SEWAGE DISPOSAL SYSTEM

A REPAIR

HOWARD COUNTY

ADDRESS 2555 Jennings Chapel Road, Woodbine, Maryland PHONE 489-4724

P 36147
Repair

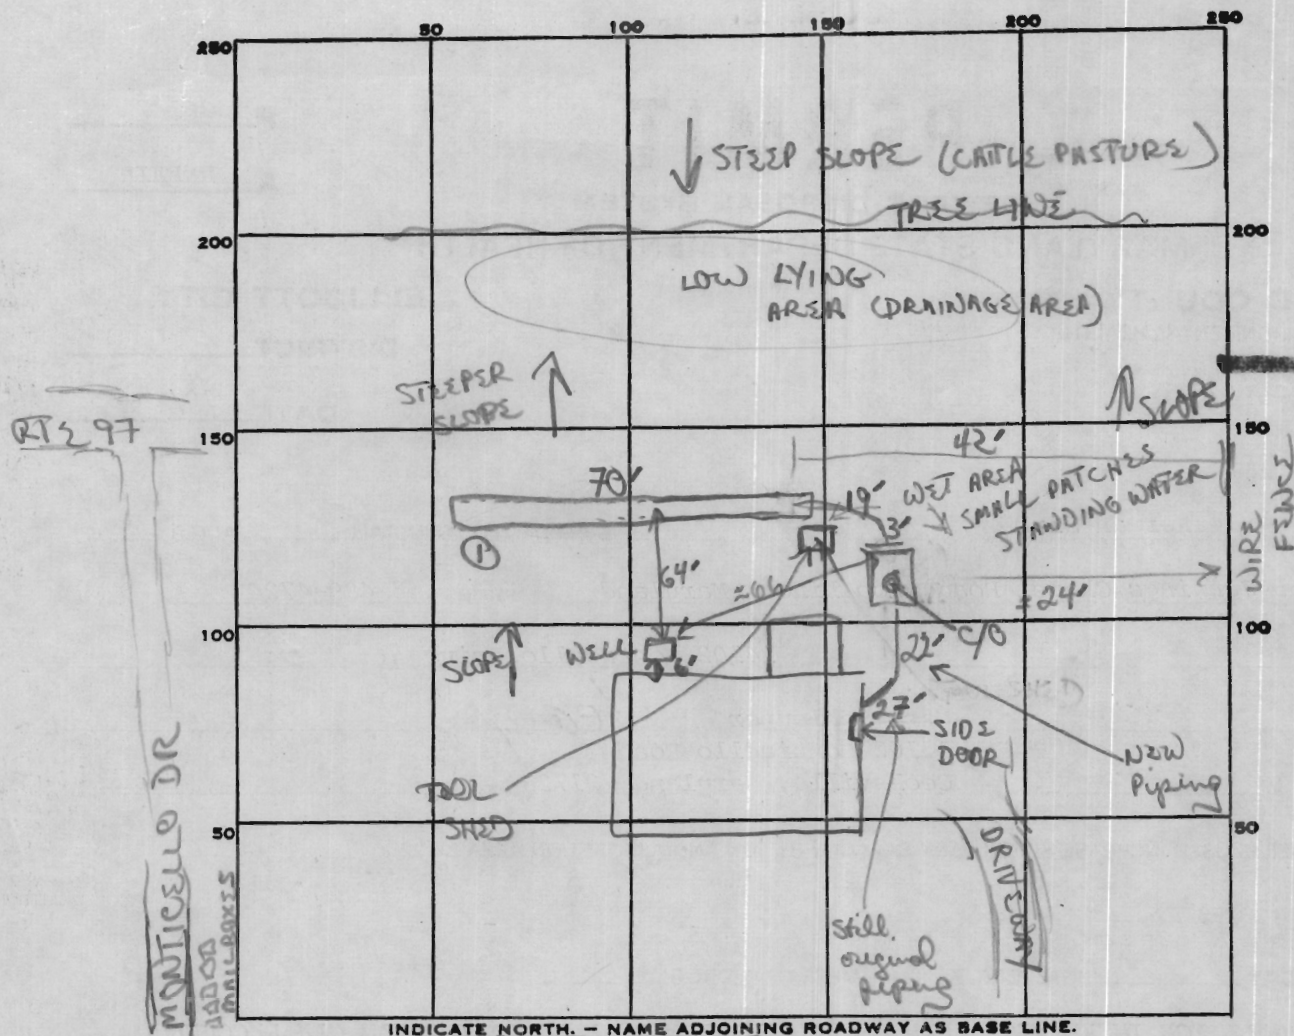
REMARKS 11/18/85 SOIL MOSTLY SANDY LOAM; APPEARS TO BE SOME MOTILED SOIL AT
BEGINNING OF TRENCH (ALSO AREA WHERE PATCHES OF 420 PRESENT), WILL DISCOVER
OLD TRENCH PIPE. TRENCH TO BE AT LEAST 60', IF MORE GOOD SOIL MAY
EXTEND A LITTLE FURTHER. WILL GIVE MIN. 480 SQ. FT. (#160/BEDROOM)
LOCATION OF TRENCH IS BEST FOR SITUATION AND ABOUT SAME DISTANCE FROM WELL
AS ORIGINAL AREA.

Had to install new S.T. Cold one metal had rotted through
OK to cover trench & all work.
